Introduction

This document contains the latest information about the AVR data book and the AVR data sheets.

**8-Bit AVR[®]
Microcontroller**

**AVR[®] Data
Book Updates
and Changes**

Figure 34 Serial Programming and Verify

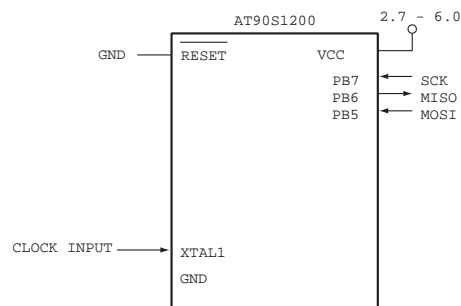
2-44 Replace figure 34 by the one below:

Figure 53 Serial Programming and Verify

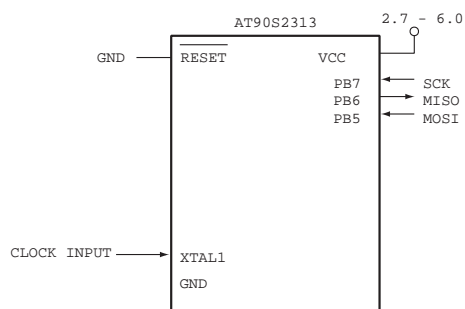
- 3-54 in the **Port D Input Pins Address - PIND** description, change the Initial Values of bits 0 to 6 from “Hi-Z” to “N/A”.
- 3-67 Replace figure 34 by the one below:

Figure 66. Serial Programming and Verify

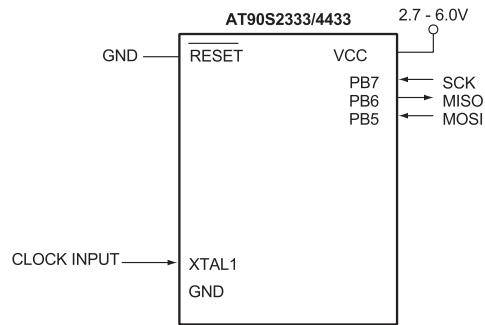
- 5-68 In the **Port D Input Pins Address - PIND** description, change the Initial Values from "Hi-Z" to "N/A".
- 5-80 In **"Serial Downloading"**, replace Figure 66 by the figure below.

Figure 64 Serial Programming and Verify

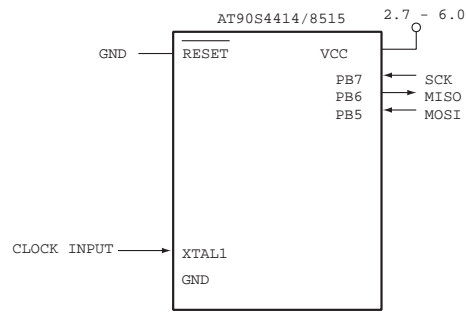
- 6-66 in the **Port D Input Pins Address - PIND** description, change the Initial Values from “Hi-Z” to “N/A”.
- 6-79 Replace **figure 64** by the one below:

Figure 40. SPI Transfer Format with CPHA = 1 and DORD = 0

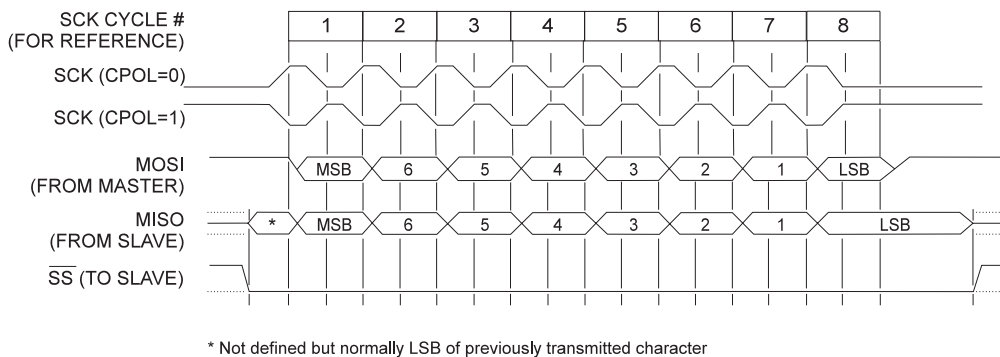
7-52 Change **Figure 40** to the figure below.

Figure 71. Serial Programming and Verify

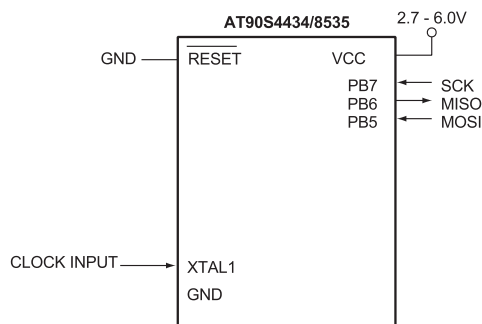
7-91 In “**Serial Downloading**”, replace Figure 71 by the figure below.

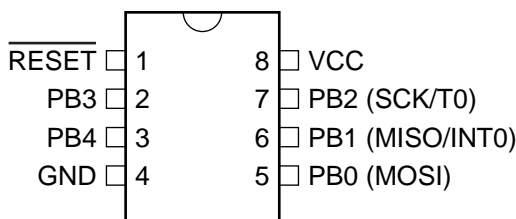
11-3 Replace **Pin Configuration** by the figure shown below.

Figure 1. The ATmega603/103 Block Diagram

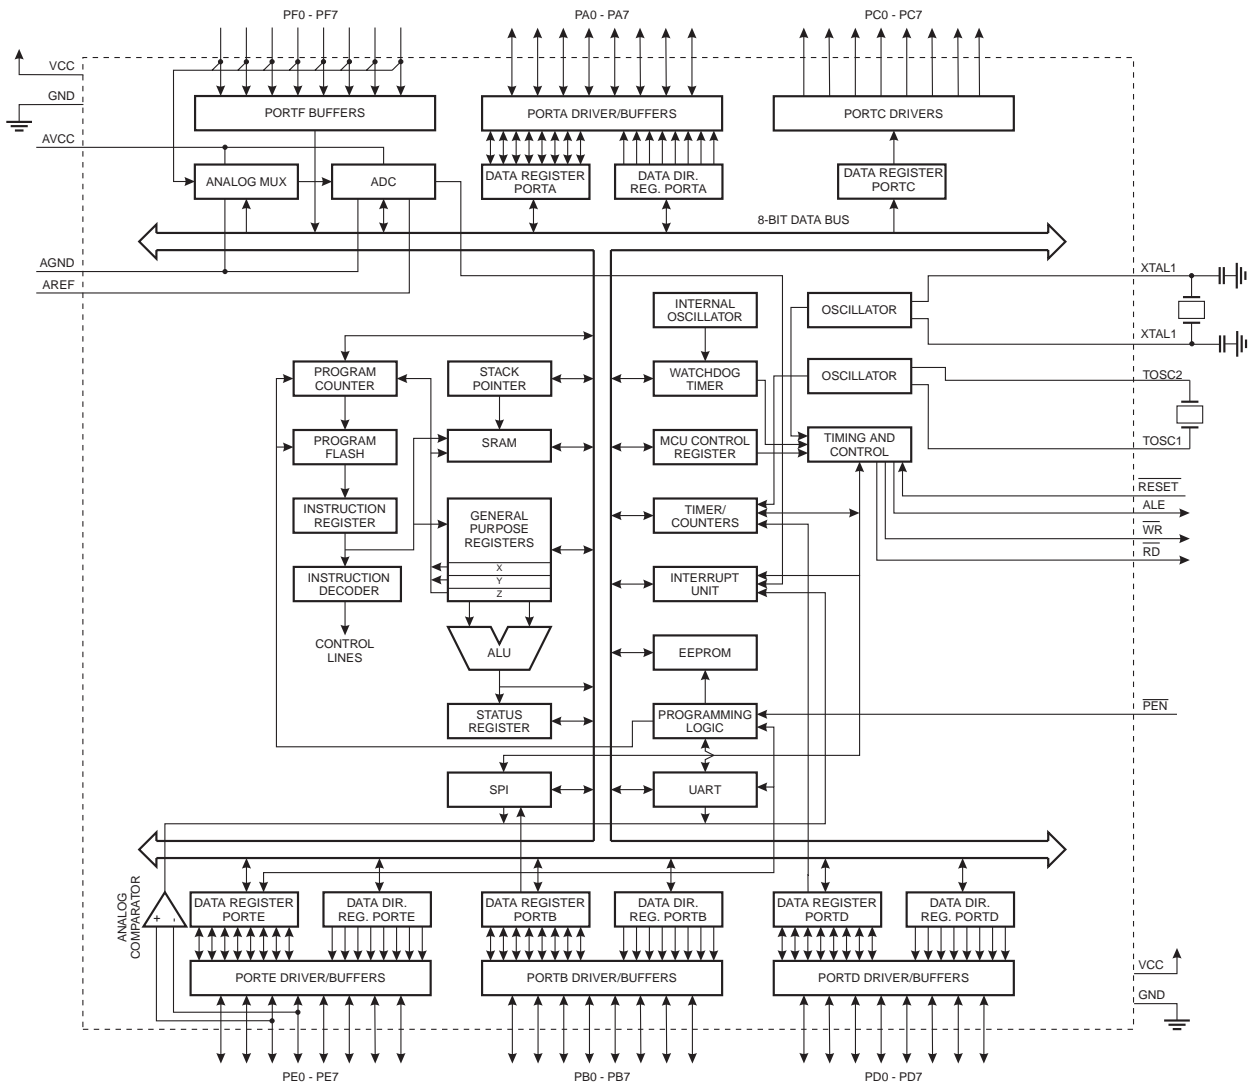
13-5 Some text and symbols are outside the visible figure frame. The complete figure is given below.

Figure 39. SPI Transfer Format with CPHA = 0 and DORD = 0

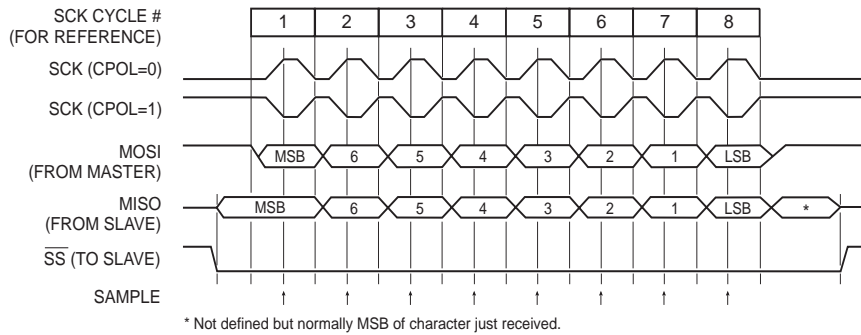
- 13-59 Replace figure 39 and 40 by
